Tip Sheet #12002

Pump Harness Fuse Update Spring Return Hydraulic Leveling

© PowerGear 1/08 Tip Sheet #12002 Rev. 0A

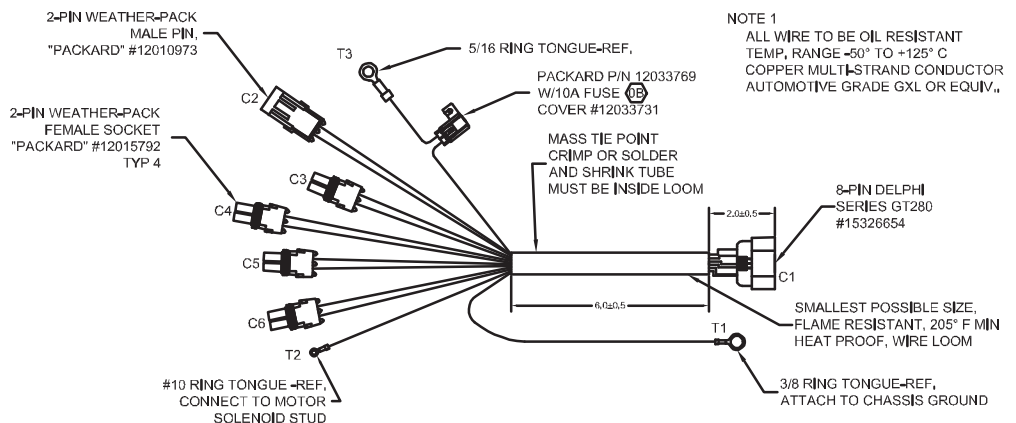
The fuse in the 1510000064 pump harness has been changed from a 5 amp to 10 amp fuse.

Condition: If, after attempting to operate the Power Gear Spring Return leveling system, the “Low Voltage” LED on the touch pad remains ON and no other buttons are functional, except on/off button, then the 5 amp pump harness fuse has blown.

Replace the fuse with a 10 amp mini fuse.
